CITY OF MINNETONKA
PLANNING COMMISSION
MAY 16, 2019

Brief Description	Minor amendment to the existing Solbekken master development plan at 5743, 5742, and 5754 Shady Oak Road.
Recommendation	Adopt the resolution approving the amendment

Re: formerly the Music Barn Property, 5740 and 5750 Shady Oak Road
2.29 acres rezoned for the 15-unit Solbekken development
Now 5734, 5738, 5742, 5746, 5750 and 5754 Shady Oak Road
Request for PUD amendment and plat approval related to revised Garage
Dimensions for the three 4-plex condominium buildings

* RED TEXT DENOTES PREVIOUS BUILDING FOOTPRINT

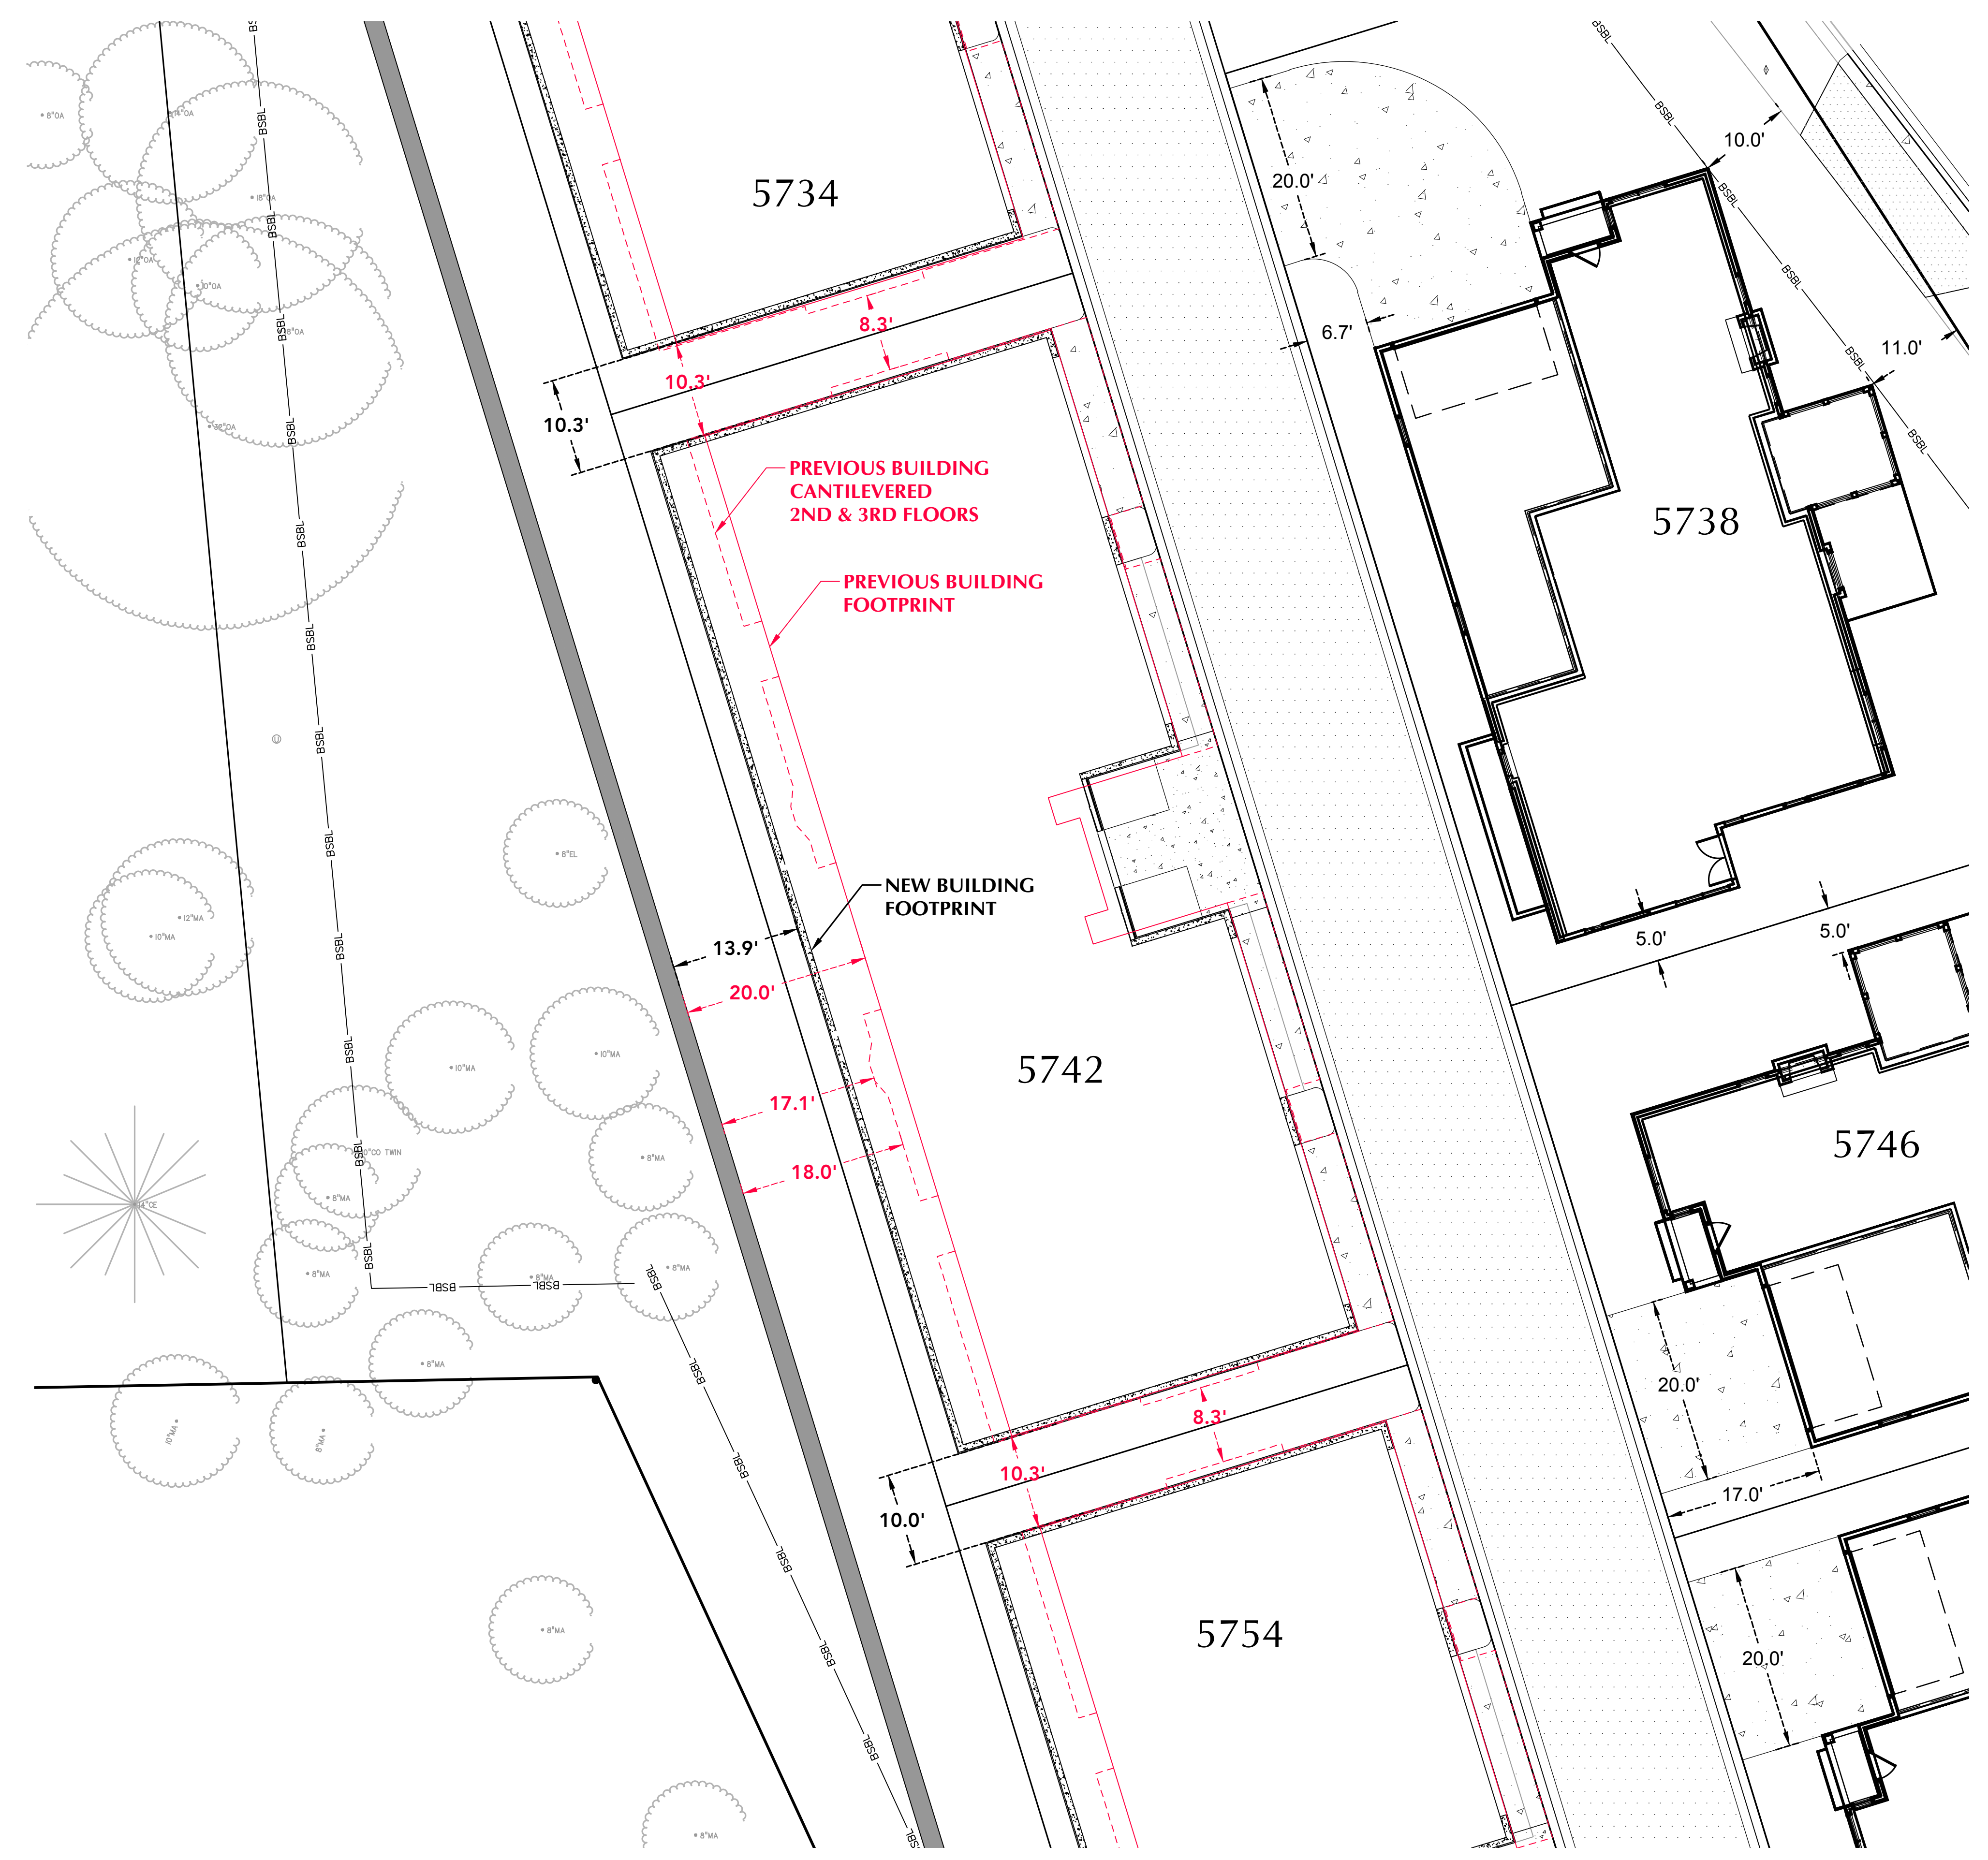
Solbekken LLC. recently submitted a revised site and building plans for the three condominium buildings. As proposed, a foundation wall would be constructed beneath second story areas previously shown as cantilevered. (While the second and third stories had a proposed front-to-back depth of 45 feet, the first story garage/storage area had a depth of 39 feet.) The foundation change is proposed to address construction cost and methods.

- Building Footprint Change Exhibit—which illustrates the current garage footprint and shows **in red color** the previous location of the west garage wall.
- Garage Plan Exhibit—First Level Floor Plan which shows the layout of the garage level now and indicates **in red color** where the west (rear) wall was located previously. There is a minor change standard for the lobby entrances to provide more space in the vestibule to allow for package delivery lockers. You will also notice a very small overhang added for a deck on the north elevation of this building (5734). The southern elevation of building 5754 has the same small overhang.
- Architectural Site Plan Amendment—While there is more detail in the civil drawings, this site plan replaces the original architectural site plan (Sheet A-1.1 in our original submission). The **red line shows** the previous boundary of the garage walls.
